Proposal for the 03 series of amendments to Regulation No. 58 (Rear underrun protection)

Submitted by the expert from Germany *

The text reproduced below was produced by the expert from Germany to introduce more stringent requirements for rear underrun protection devices. This proposal supersedes ECE/TRANS/WP.29/GRSG/2013/27 (see report ECE/TRANS/WP.29/GRSG/84, para. 33). The modifications to the current text of UN Regulation No. 58 are marked in bold for new or strikethrough for deleted characters.

Figure 1

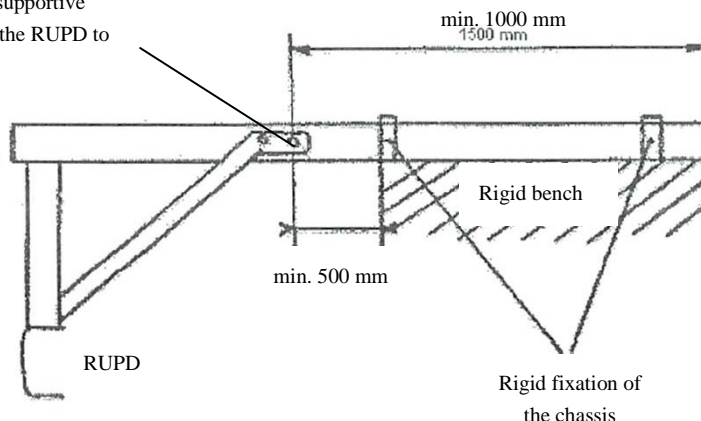
- "1.2. In the case of paragraphs 1.1.2., ~~and 1.1.3~~ the parts of the vehicle chassis ~~or to the rigid test bench~~ shall be on the vehicle. **The part of the chassis can be fixed on a rigid test bench as shown in Figure 1.**
